## Product Change Notification / NTDO-14MNBI131

CCB 5025 Final Notice: Qualification of G700 as a new mold compound material for selected Micrel MIC3490, MIC52xx, MIC62xxxM5, SPN020xxxx device families available in 5L SOT-23 package assembled at STAR assembly site.

**Pre and Post Change Summary**  
**PCN #: NTDO-14MNBI131**

## Pre Change

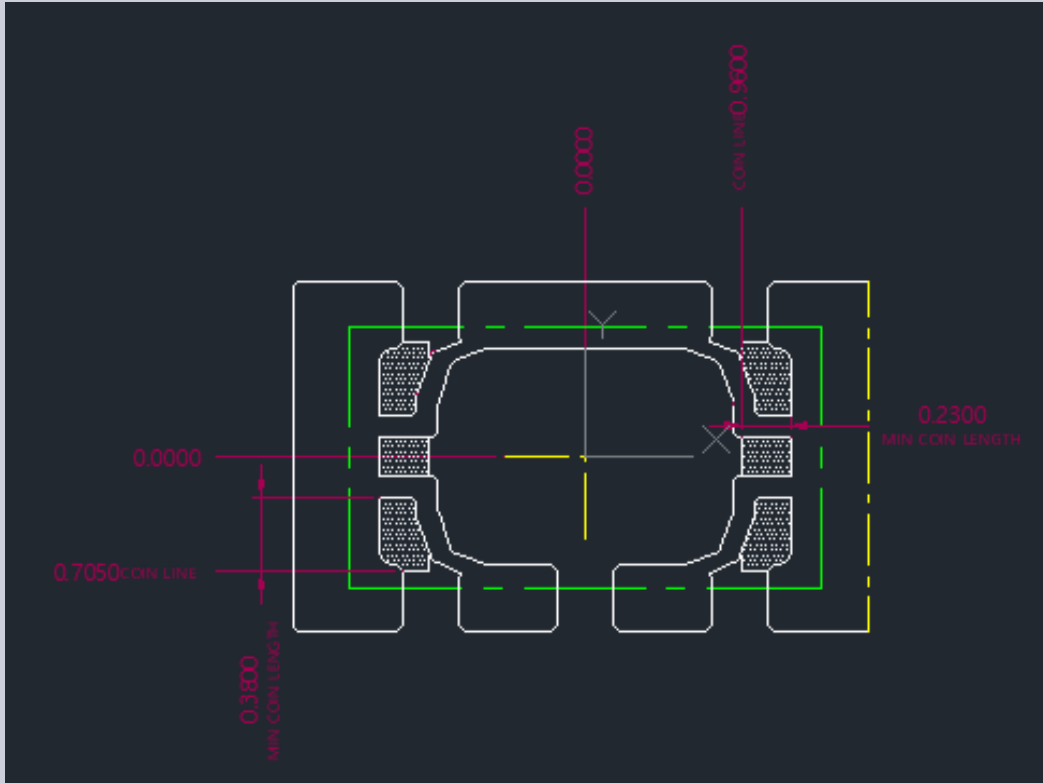
DAP Surface Prep	NiPdAu with Roughened
Lead-frame Material	C194

## Post Change

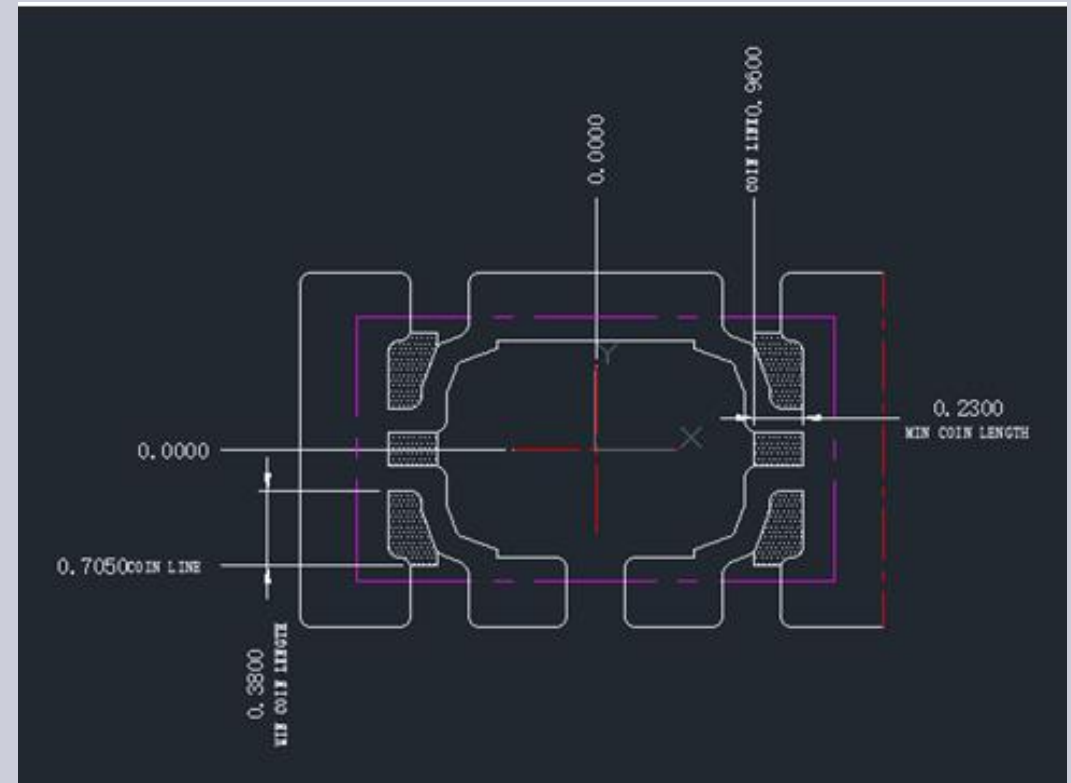
DAP Surface Prep	NiPdAu (Ag with Roughened)
Lead-frame Material	C194
